BULLETIN NO. 281

MACHINE: Hydra-Spiker Model B

SUBJECT: **Locking Driving Cylinder**

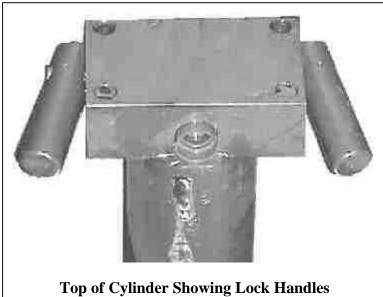
> There is now a new Locking Driving Cylinder available for these machines. The new cylinder, part number 28552423, incorporates an integral mechanical locking device to prevent accidental extension of the driving cylinder rod during travel. Preventing accidental extension can eliminate downtime required to replace a gun assembly damaged by the extended rod hitting an obstruction. The operator easily engages the lock with a lever built into the top of the cylinder.

This new cylinder is interchangeable with the original cylinder, part number 28552459. However, longer mounting bolts are required to attach the locking cylinder to the machine. Four of these bolts, part number 2590136, are included with each cylinder.
